**Environmental  
Planning  
Commission**

*Agenda Number: 04  
Project Number: 1010546  
Case #: 16EPC-40021  
June 09, 2016*

**Staff Report**

<b>Agent</b>	Modulus Architects
<b>Applicant</b>	Tecolote Resources, Inc.
<b>Request</b>	<b>Site Development Plan for Building Permit Amendment</b>
<b>Legal Description</b>	Tract A-2, Lands of Coogan & Walters & Southwestern Land Development Corp, together with Tracts B and C Milne Plaza Subdivision, and Tract A Lands of MRGCD Map 39
<b>Location</b>	The SW corner of Central Ave. SW and Atrisco Dr. NW
<b>Size</b>	Approximately (≈) 13 acres
<b>Zoning</b>	C-2 (SC)

PROJECT: WEST CENTRAL PLAZA-PROP. ADDITION  
 4308 CENTRAL AVE SW  
 ALBUQUERQUE, NEW MEXICO  
 PROJECT MANAGER: JEFF WOOTEN  
 DRAWN BY: JTW  
 JOB NO: 2015064  
 SHEET NO: 1  
 TOTAL SHEETS: 5  
**CONCEPTUAL UTILITY PLAN**

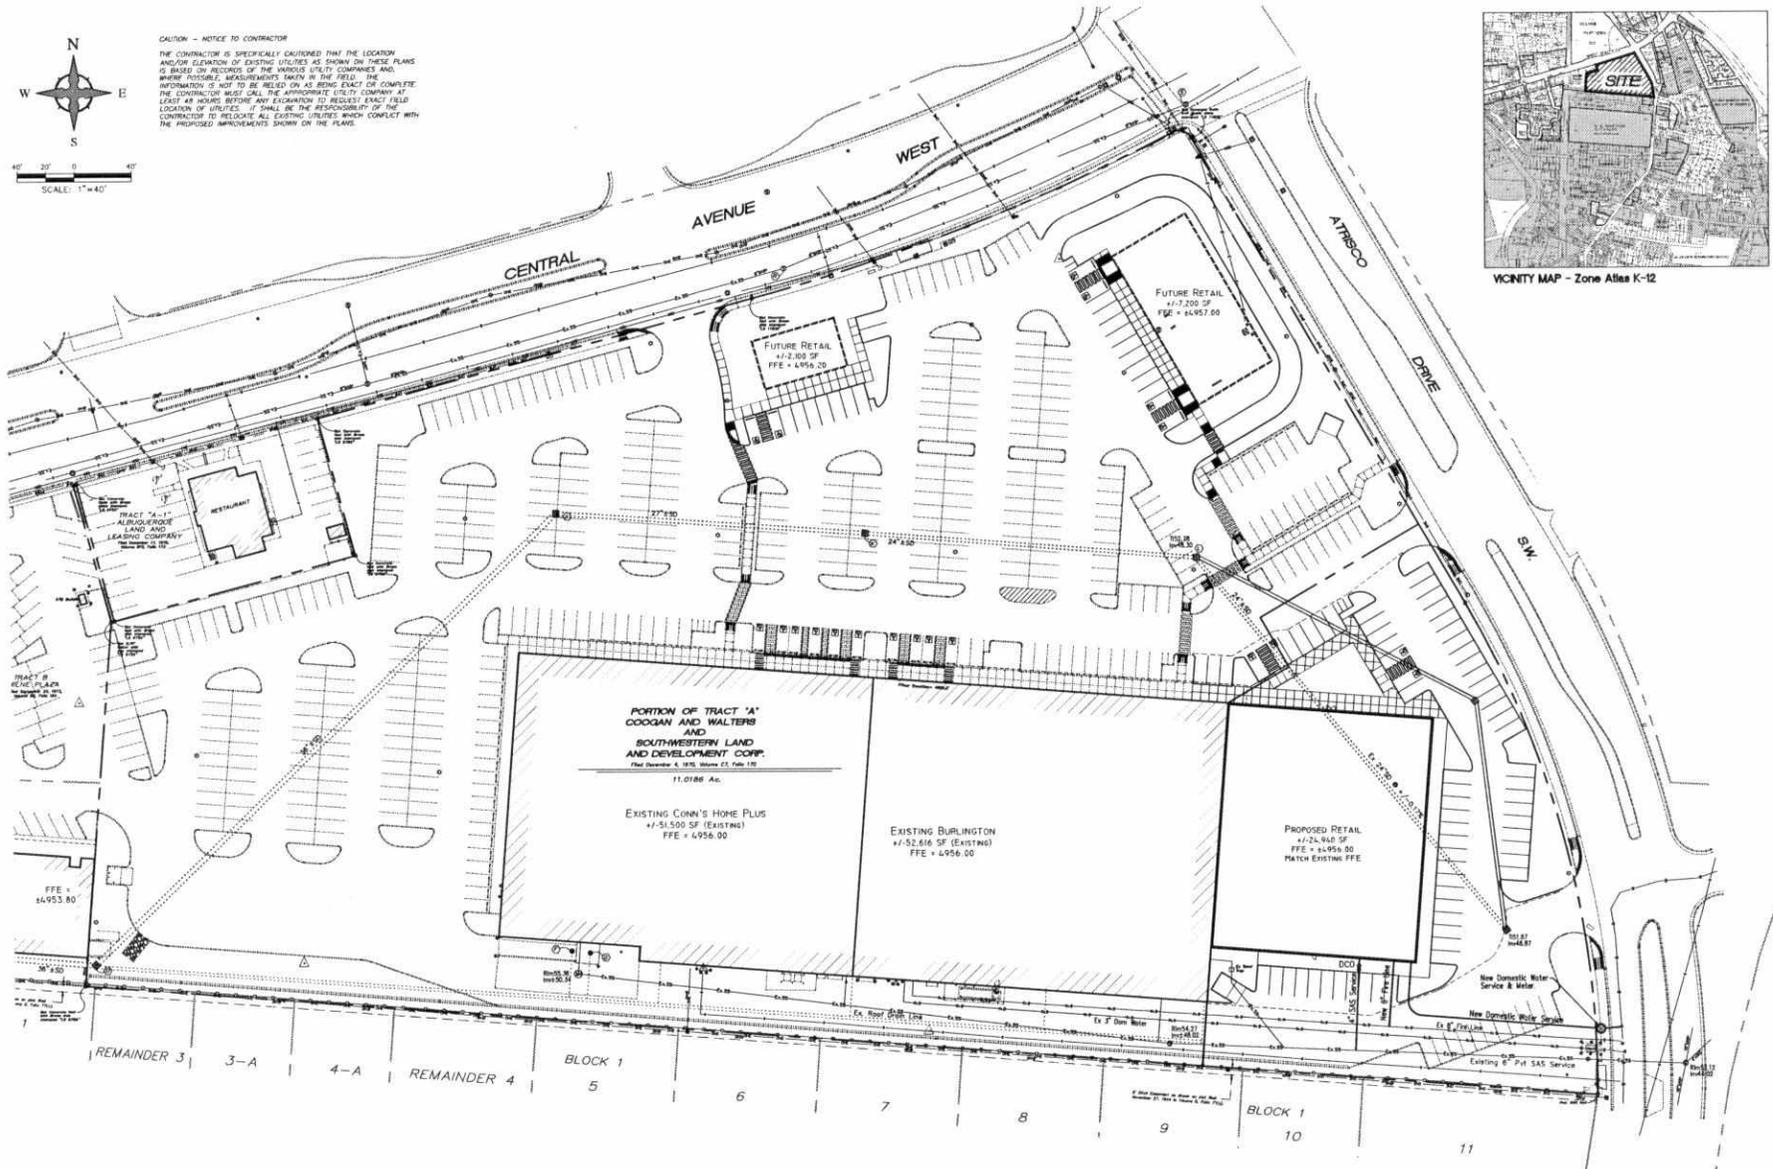
A new water line and a new sewer line would connect to the proposed addition from Atrisco Dr. and from the lines that run in back of the existing buildings. Any fire hydrants need to be shown. Utility easements, if any, should be shown on the utility plan.

- A. Show location of any easements.
- B. Indicate location of fire hydrant(s).

PROJECT BY	WEST CENTRAL - ATRISCO	DATE	2.29.15
PROJECT NO.	1010046	REV. NO.	C-5
PROJECT ADDRESS	4200 CENTRAL AVE SW ALBUQUERQUE, NEW MEXICO	DATE	
DRAWN BY	CRISTO CALVERT	CHECKED BY	K-AT
DATE	2.29.15	DATE	
SCALE	AS NOTED	SCALE

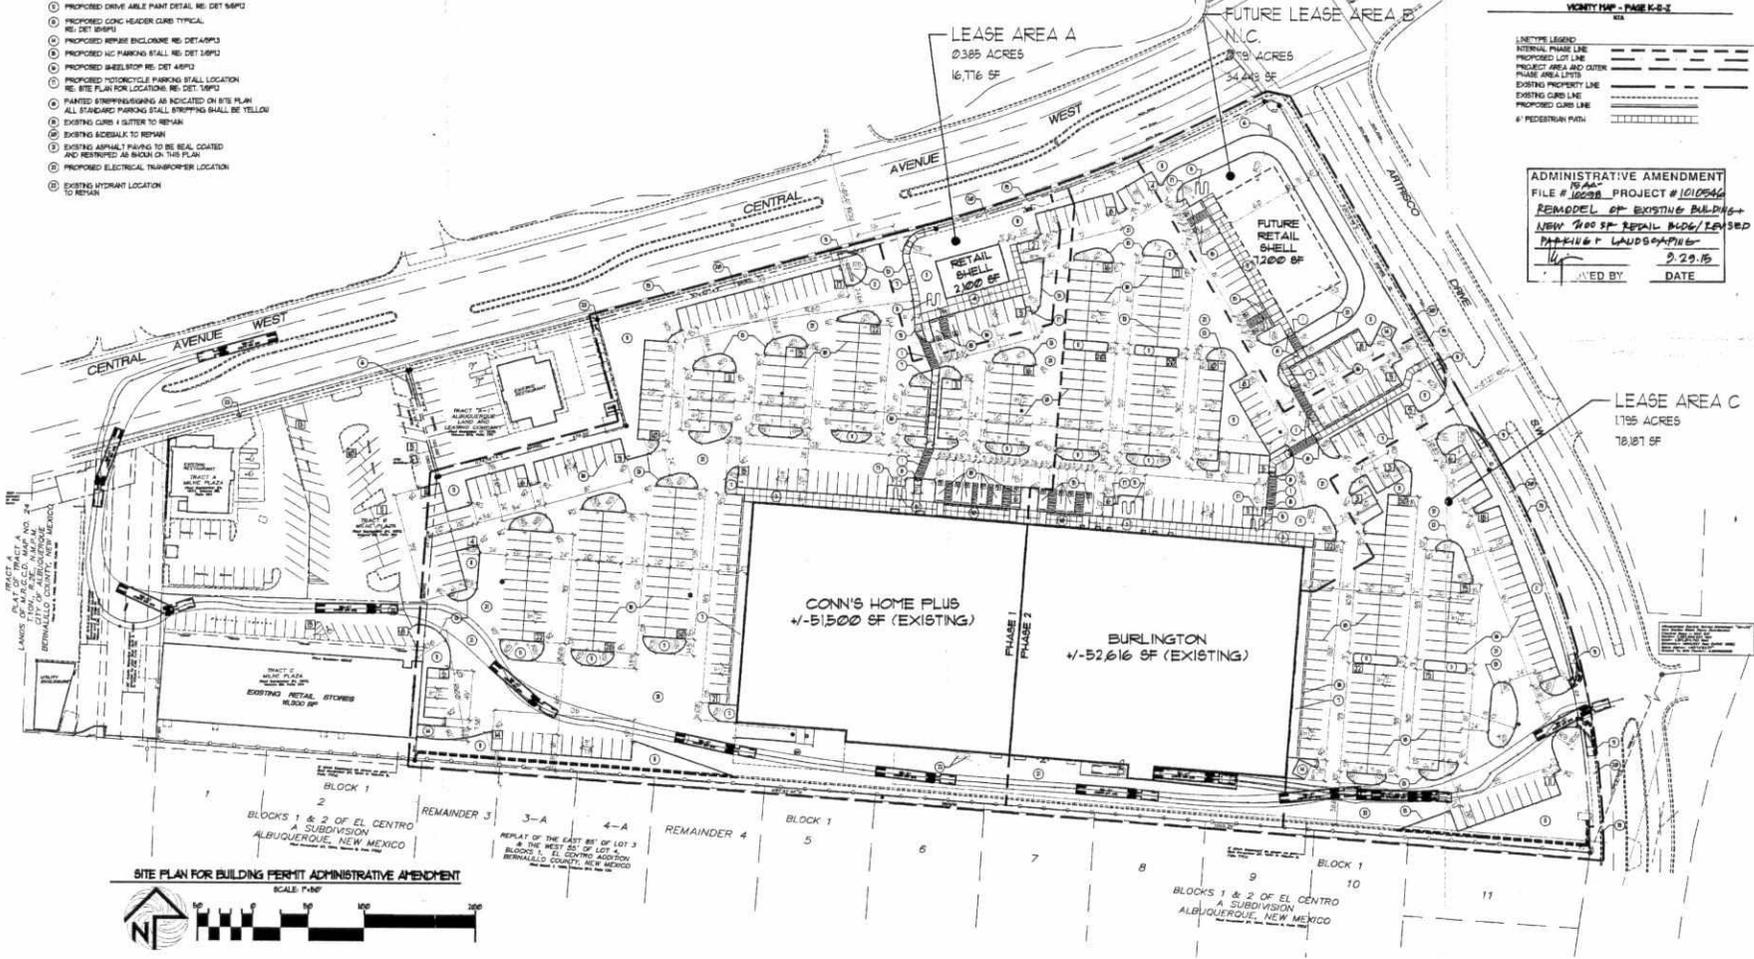
I was unable to locate parking calculations on the site plan. Parking shall comply with C-2 standards.

4. Parking:
  - A. Ensure that the total number of parking spaces provided is shown accurately on the site development plan and list required parking as 569 spaces.

- B. Show the math for the handicap parking and motorcycle parking calculations and remove the rates that don't apply.
  - C. Provide a calculation for the bicycle parking.

MAJOR ANCHOR ELEVATIONS - SUBJECT TO GOVERNMENTAL APPROVAL  
SCALE: 1/8" = 1'-0"

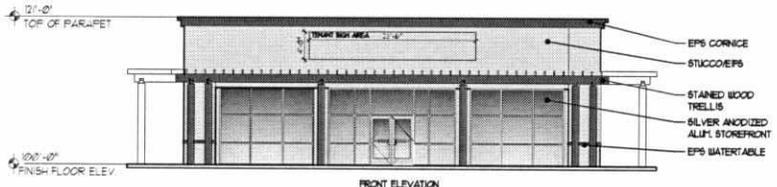
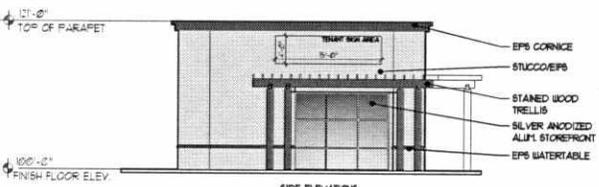
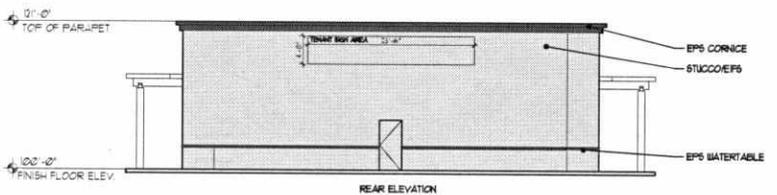
- A. The south elevation shall be articulated over at least 50% of the façade's length pursuant to §14-16-3-18(C)(3), General Building and Site Design Regulations for façades 100 feet or greater.
- B. Provide calculations for seating and show compliance with [§14-16-3-18(C)(3)].
- C. Provide a bench detail.
